P5023A-04

# Information Only Service Note

# P5023A Keysight Streamline USB Vector Network Analyzer

False alarm on self-test failure on firmware revision of A.13.40.02 - DDR3 memory removal

#### Self-test

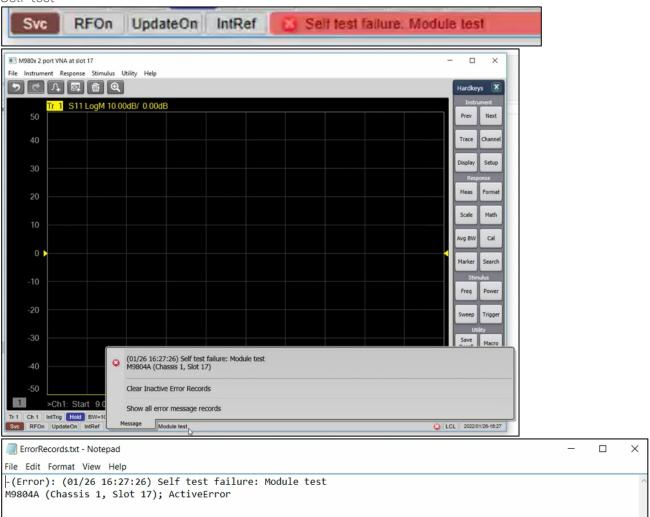
The on board DDR 3 memory in VNA is not in use since its release. With the removal of DDR 3 memory IC on newer P502xA VNA, right after firmware is launched, false alarm (self-test failure) will be reported as shown. This has no impact to VNA performance and specifications.

Similarly, firmware will report a false failure in Operator check. Shown are the error messages example on VNA firmware UI.

For users with firmware revision of A.13.40.02, Update firmware to revision A.13.70.02 or newer to resolve this false alarm on self-test.
